UNITED STATES PATENT AND TRADEMARK OFFICE

APPLICATION NO.	FILING DATE	FIRST NAMED INVENTOR	ATTORNEY DOCKET NO.	CONFIRMATION NO.
10/796,692	03/09/2004	Colby Nash	FY.51040US1A	2923
20995 7590 09/20/2007 KNOBBE MARTENS OLSON & BEAR LLP 2040 MAIN STREET FOURTEENTH FLOOR IRVINE, CA 92614			EXAMINER BROWN, DREW J	
			ART UNIT 3616	PAPER NUMBER
			NOTIFICATION DATE 09/20/2007	DELIVERY MODE ELECTRONIC

Office Action Summary

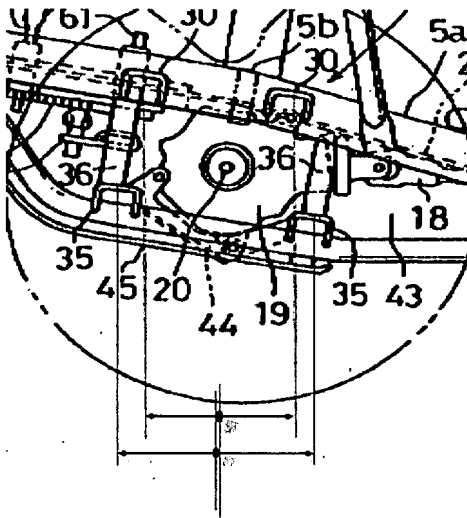
from the frame (Figure 4), the frame including two frame members (5 and 34) extending generally fore to aft, the vehicle further comprising front (30) and rear (35) sets of retainers being coupled to the frame members, the retainers of at least one of the front and rear sets being spaced apart from each other in a fore-to-aft direction with a fore-to-aft spacing between the retainers of the rear set (Figure 5), each retainer of the front set being configured to retain an end of a respective suspension arm (31) and each retainer of the rear set being configured to retain an end of a respective suspension arm (33) so as to permit the respective suspension arm to swing relative to the respective set of retainers (Figure 4). A front retainer of each set is configured to retain a front end of a respective suspension arm in a manner permitting the respective suspension arm to swing relative to the respective set of retainers (Figure 4), the front retainers being spaced apart from each other in a fore to aft direction by a distance which is different than a distance by which the rear retainers are spaced apart from each other in a fore to aft direction ($d_1 > d_2$ as shown in Figure below).

With respect to claim 36, a frame (10) and upper (31) and lower (33) suspension arms, the frame extending generally horizontally fore to aft, the upper and lower suspension arms each including two ends being pivotally coupled to the frame (Figure 4), the ends of upper suspensions arm being spaced apart from each other fore to aft at a first length, the ends of the lower suspension arm being spaced apart from each other fore to aft at a second length, wherein a midpoint of the first length is not aligned with a midpoint of the second length along a vertical line (see Figure below).
